## **Development Facilitation Team (DFT) – Review Comments**

**Project No: PR-2018-001681      Date: 06/25/2025      Agenda Item: #2      Zone Atlas Page: L-9**

**Application For: MAJOR\_PLT-2025-00008 – MAJOR PRELIMINARY PLAT (DHO)**

**Project Name:** Sunset Apartments

**5-6(D)(1) Required Street Trees**

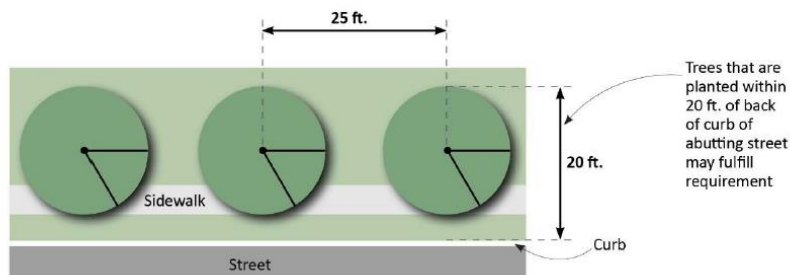
For future development street trees will be required along Sunset Gardens Rd SW and 86th street per the IDO and the Street Tree Ordinance.

5-6(D)(1)(a) All development shall comply with Part 6-6-2 of ROA 1994 (Street Trees) and any standards developed by the Parks and Recreation Department or other City department to implement that Ordinance. Trees are generally required along street frontages every 25 feet on center unless specified otherwise in Part 6-6-2 of ROA 1994 (Street Trees). Along street frontages where street trees are required, trees that are planted within 20 feet of the back of curb of the abutting street may fulfill this requirement. (See figure below.)
